Item Name: Crosstube Turning Detail

DART AEROSPACE LTD	Work Order:	97870
Description: Crosstube Assembly	Part Number:	D407-667-145
Inspection Dwg: D407-667-145 Rev: C		Page 1 of 2

DRAWING NO. D407-667-145	TITLE CROSSTUBE ASS'Y (407 HIGH FWD)	REV. C	DART AEROSPACE LTD ENGINEERING ORDER		D.E.O. NO. D407-667-145-C-1	SHEET NO. SHEET 1 OF 1	SCALE NTS
DRAWN 97	CHECKED ASS	MFG. APPR. 188	APPROVED WD		DE APPR. H		
DATE 11.07.15	DATE 11.07.22	DATE 11.07.22	DATE 11/07/22		DATE 11.07.21

DRAWING NO. D407-667-145	TITLE CROSSTUBE ASS'Y (407 HIGH FWD)	REV. C	DART AEROSPACE LTD ENGINEERING ORDER		D.E.O. NO. D407-667-145-C-2	SHEET NO. SHEET 1 OF 1	SCALE NTS
DRAWN AJS	CHECKED A	MFG. APPR. E	APPROVED 40	DE APPR. H			
DATE 12.08.02	DATE 12.08.02	DATE 12.08.02	DATE 12.08.02	DATE 12.08.02

DETAIL P
BONDING STRAP INSTALLATION 2 PL

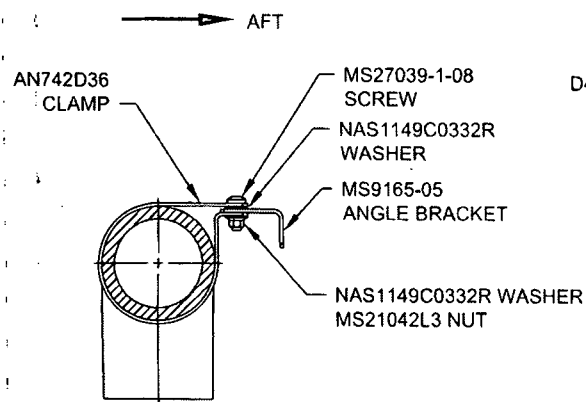
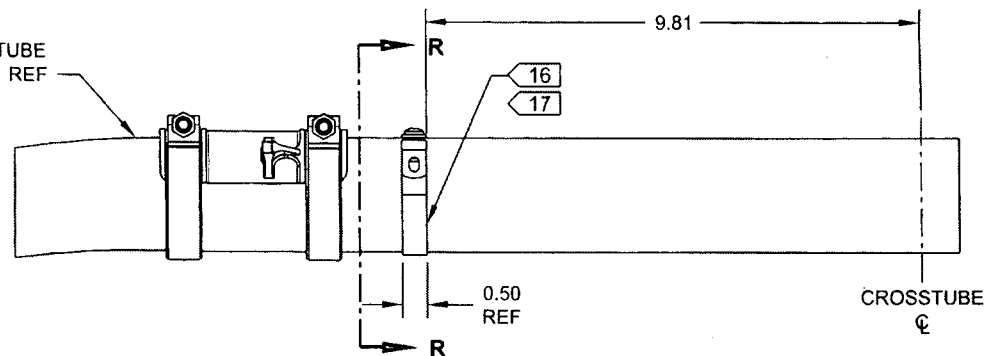
ADD ELECTRICAL GROUNDING STRAP

ITEM	QTY -145	PART NUMBER	DESCRIPTION
1	X	D407-667-145	CROSSTUBE ASSEMBLY (407 HIGH FWD)
10	2	AN742D36	CLAMP
11	2	MS9165-05	ANGLE BRACKET
12	2	MS21042L3	NUT (OR MS21042-3)
13	2	MS27039-1-08	SCREW
14	4	NAS1149C0332R	WASHER (OR AN960C10L)

- 16) MASK AREA UNDER CLAMP PRIOR TO PAINTING
- 17) SEAL EDGES WHERE AN742D36 CLAMP MEETS WITH THE CROSSTUBE USING SIKAFLEX-241/-291 OR MIL-S-8802 CLASS B2 OR PROSEAL 890 SEALANT
- 18) PERFORM RESISTANCE CHECK TO ENSURE MAX RESISTANCE IS 10 MILLIOHMS
